**Re: Wisconsin Power and Light Company – Columbia Energy Center
Response to July 26, 2011 EPA letter and Final Report Round 7 Dam
Assessment**

Columbia Energy Center Final Report Round 7 Dam Assessment Recommendations

Re: Technical Assessment
Response to EPA Comments of July 26, 2011
Columbia Energy Center – Pardeeville, WI

JOB	154
SHT.	FIGURE 1
DWG.	SITE PLAN

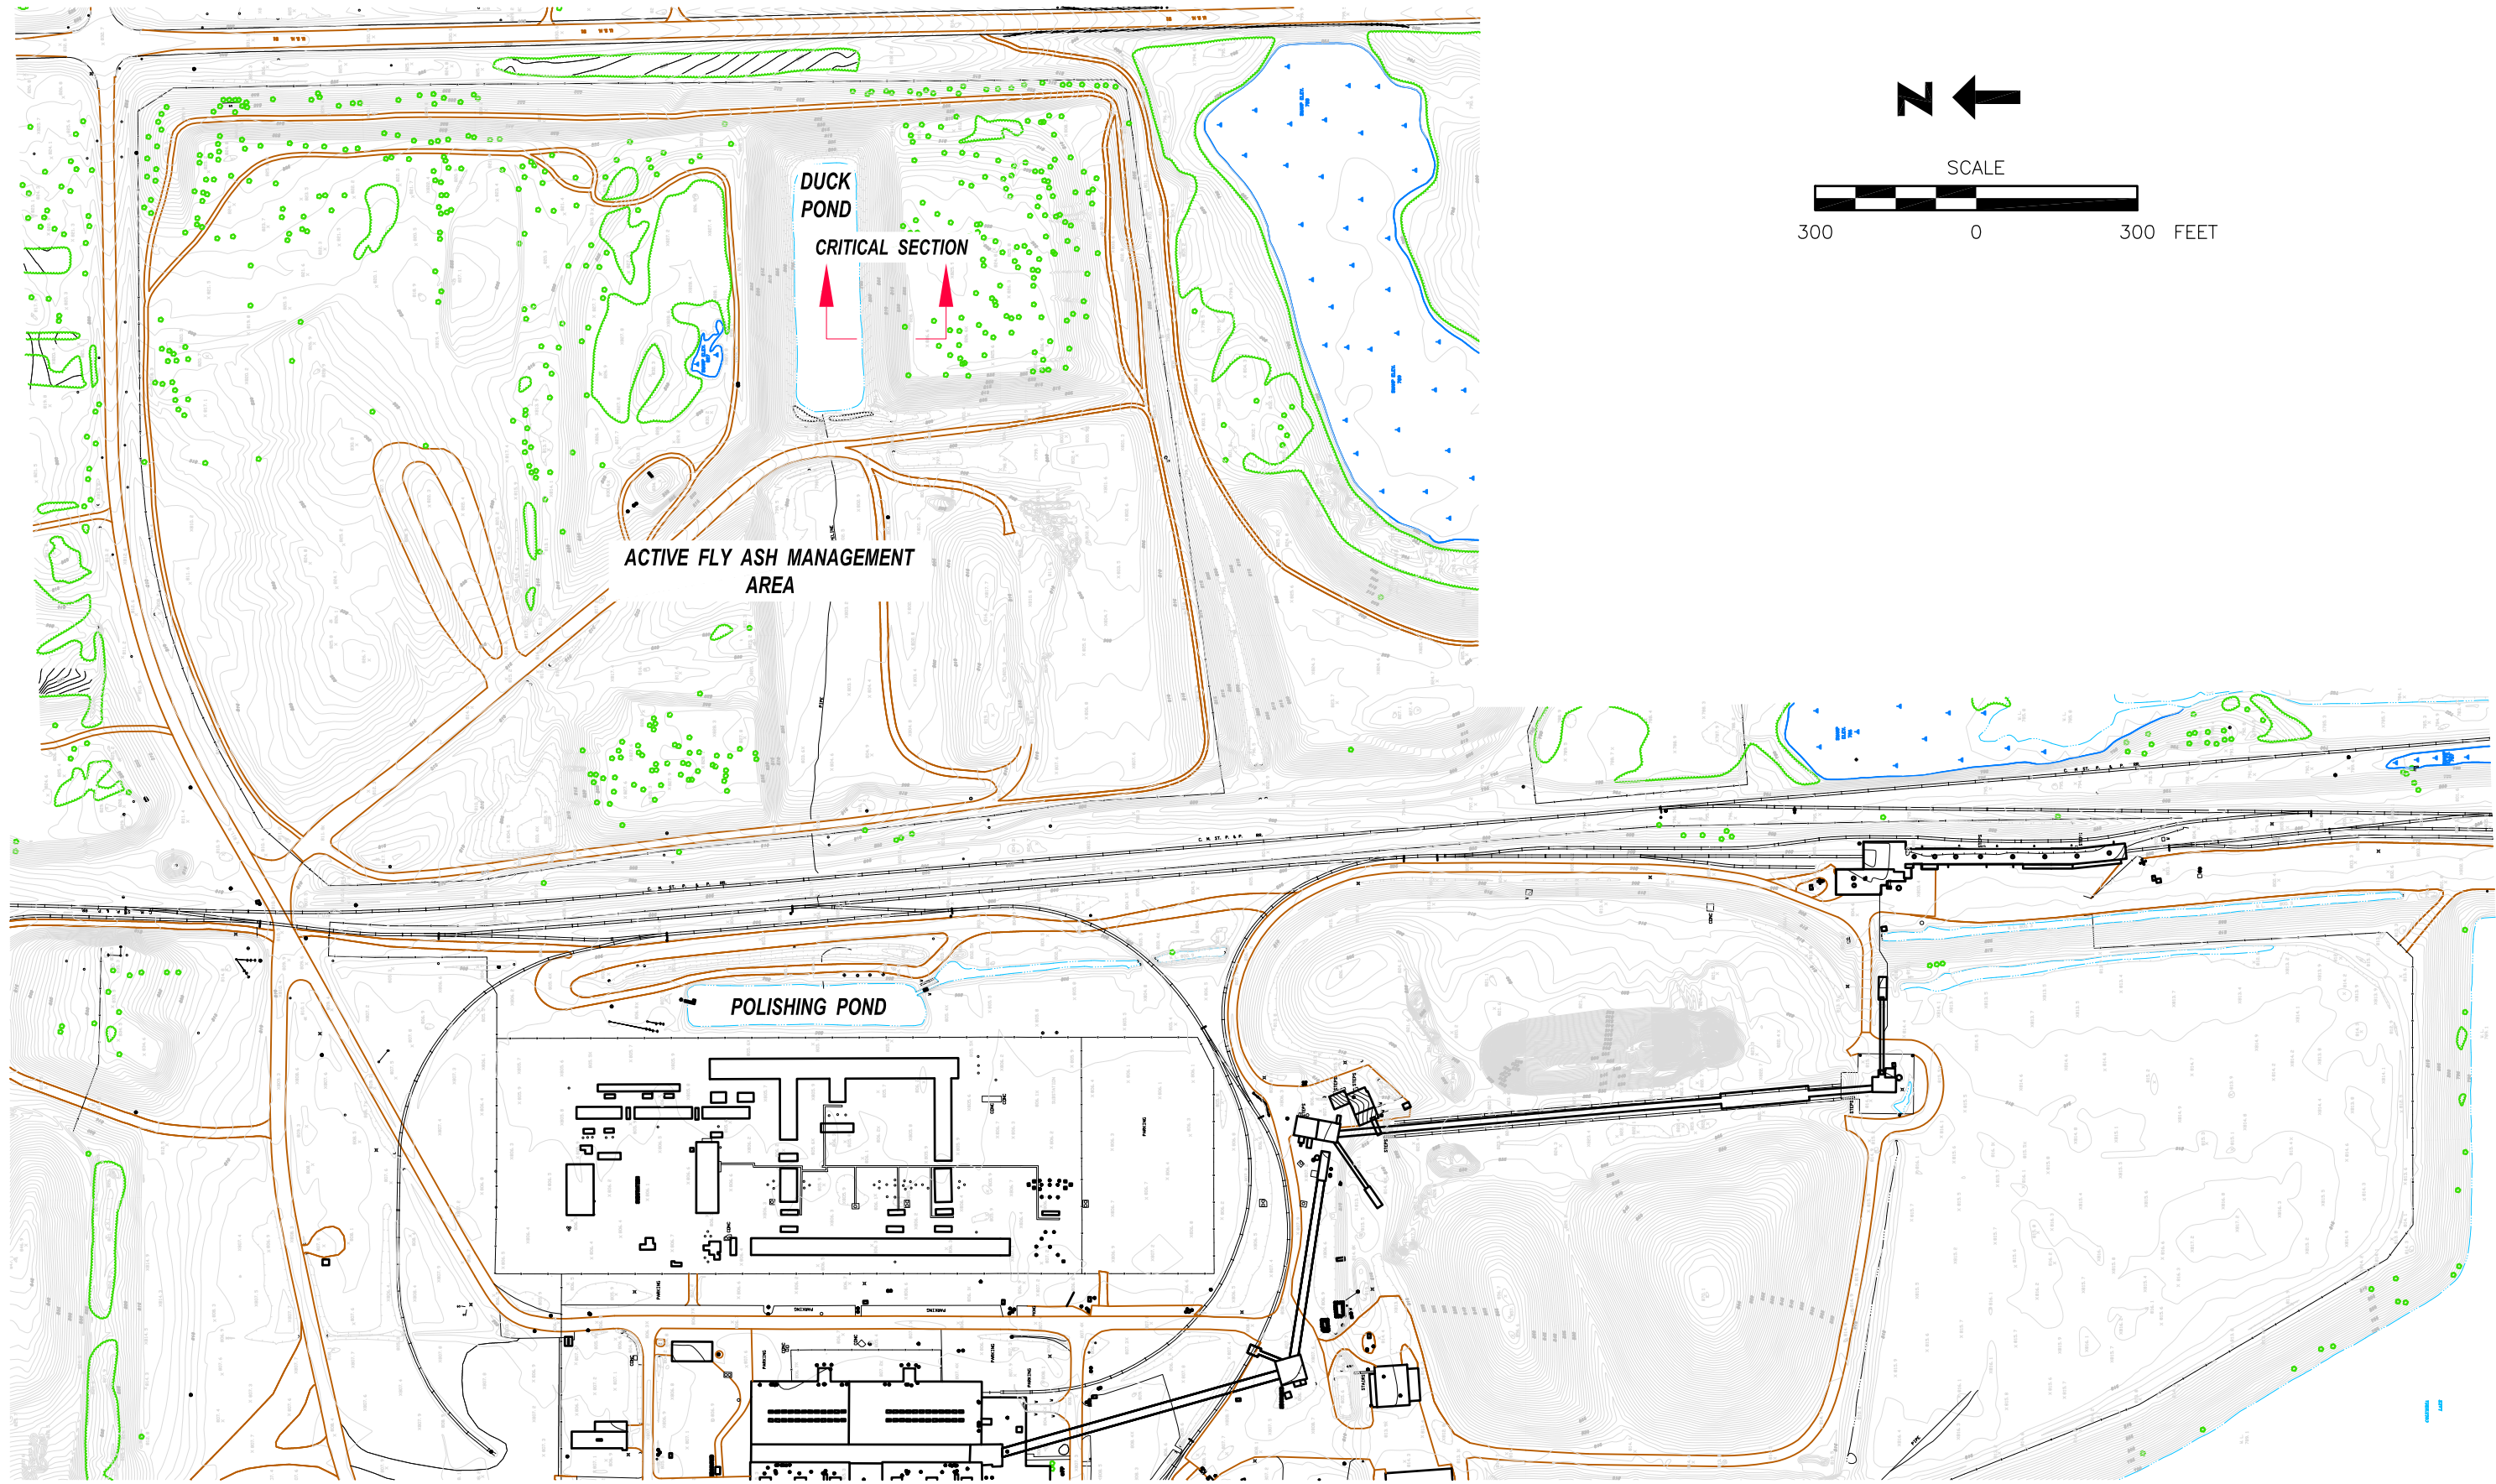
1. Evaluate the extent of wave action erosion on the upstream slopes of the Primary Ash Pond (PAP)

2. Perform a hydrologic/hydraulic analysis of the polishing pond to determine the adequacy of the current and designed operating conditions and design to accommodate the appropriate precipitation event.

In the north-south direction the PAP is 510 feet wide at its widest point and in the east-west direction the pond is 1320 feet long, including the bottom ash settling sluice on the western end of the pond, Figure 1. Waves are generated by wind traction on the pond water surface and the longest fetch direction of 1320 feet with a westerly prevailing wind will produced the largest wave in the pond. The median wind speed not the maximum gust speed controls the setup of the fetch induced wave. For Madison Wisconsin, the 5% probability and 1% probability median wind speed are 25 and 30 miles per hour, respectively¹.

The polishing pond (PP), Figure 1, was originally used as the final settling pond for the discharge at WPDES Outfall 002. As presently operated, the facility maintains the water level in the SAP to eliminate discharges to the PP. Consequently there is no discharge from WPDES Outfall 002. The PP still collects surface water that falls directly into the basin and on approximately 1 acre of adjacent ground surface that drains to the pond. The flat transformer yard directly west of the PP drains to WPDES outfall 003.

Slope Stability Analyses Results Ten Most Critical Surfaces Per Loading Case Columbia Generating Station

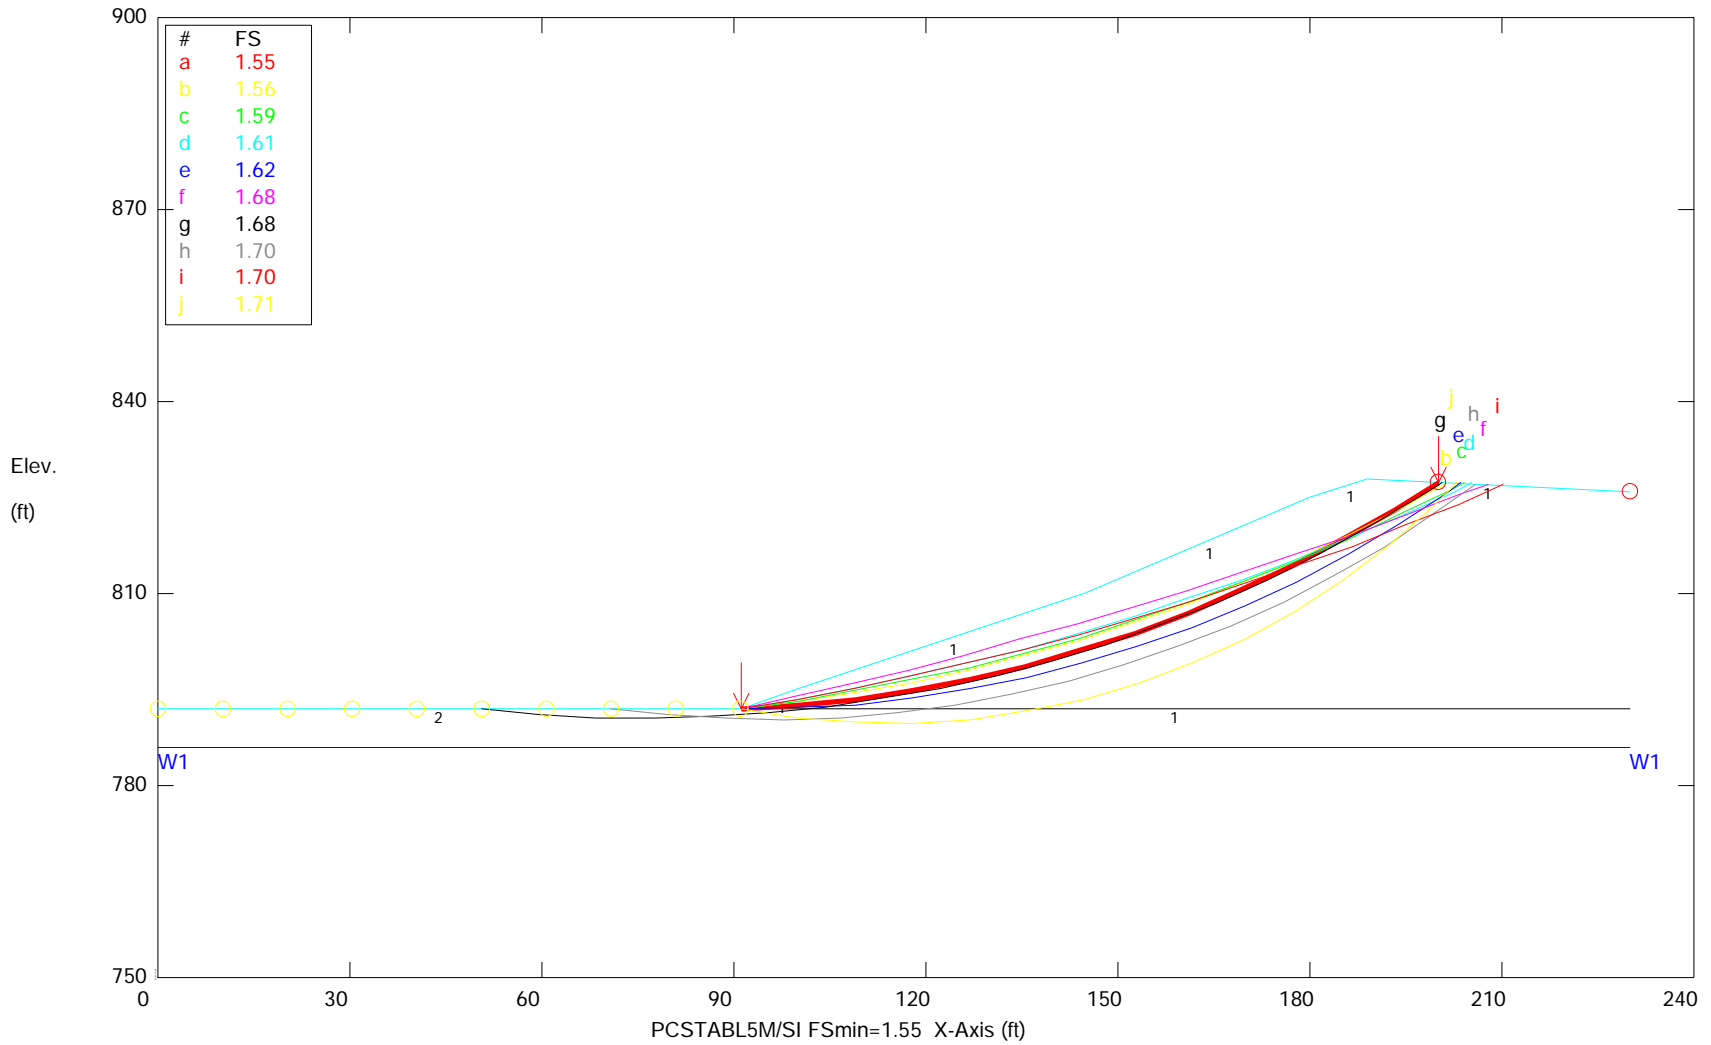
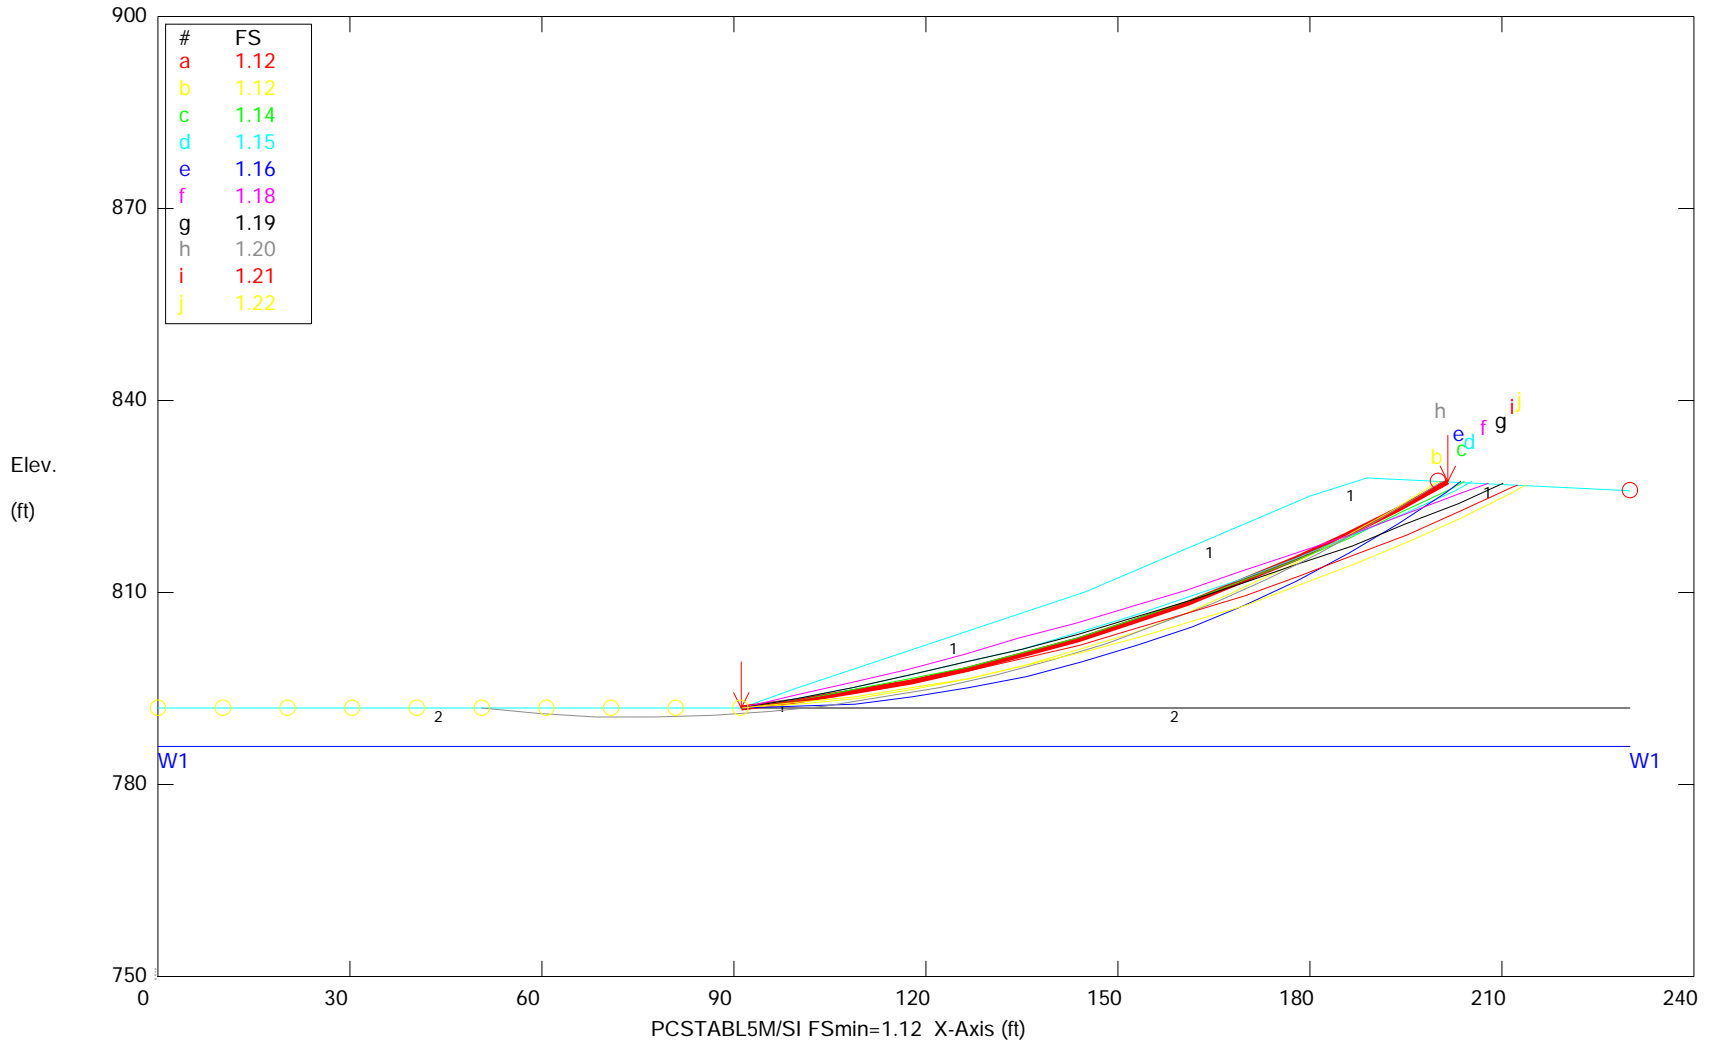
3. Evaluate the slope and seepage stability of the Landfill Seepage Pond (LSP) based on current operating conditions and methodologies.

An analysis of the ash fill was made to determine the stability of the ash fill. The analysis assumes that the fill is compacted dry ash presently handled at the facility. The analysis shows that the static factor of safety for the landfill slope is an acceptable 1.5 and the Earthquake loading case factor of safety is an acceptable 1.1. The Site information shows that there is no groundwater seepage into the LSP other than what may infiltrate through the landfilled ash. The LSP is incised and the only possible slope failure is into the pond from the landfilled ash. Analysis shows that the factor of safety for an inward failure is acceptable.

The results of the slope stability analysis are in Attachment D.
